**MASCOT COMMERCIAL – Botany Rail Upgrade  
Environmental Impact Statement Due Diligence**

Below is APG's initial review of the EIS documentation titled "Botany Rail Duplication EIS" supplied by the Australian Rail Track Corporation in relation to the asset property located at 241 O'Riordan Street, Mascot)

**Figure 9 Example of Indicative Construction Noise Levels during Rockbreaking**

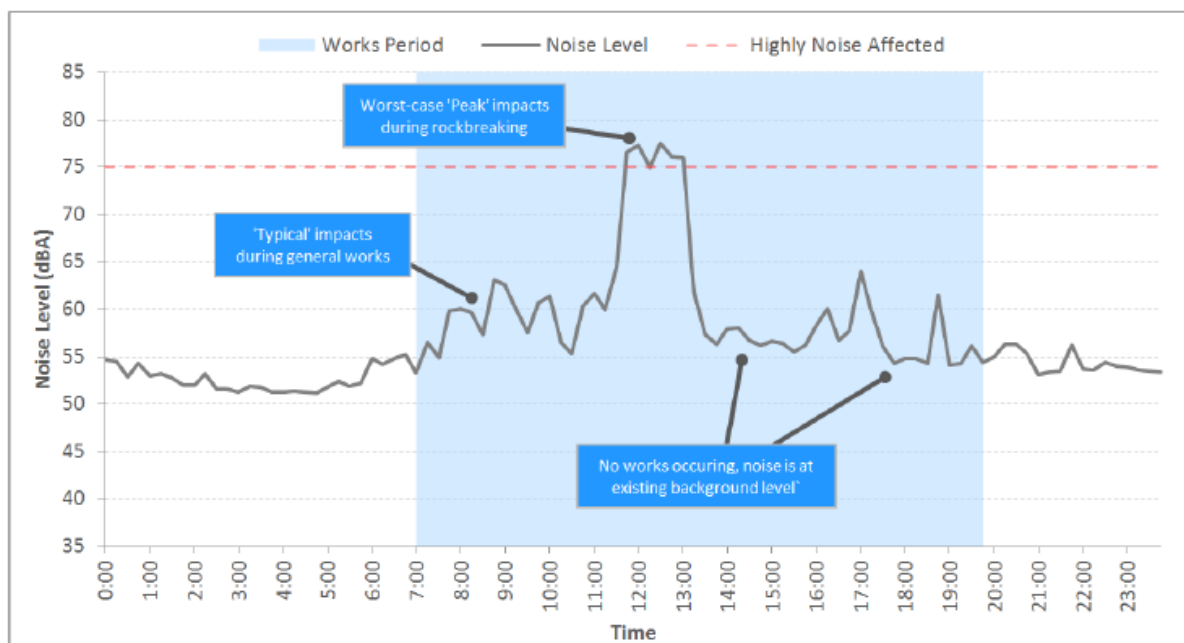
- Noise - Will not exceed average dB levels for the area except for Rock-breaking activity during midday. Worst case scenario is a >20dB noise increase for the asset & occupants.
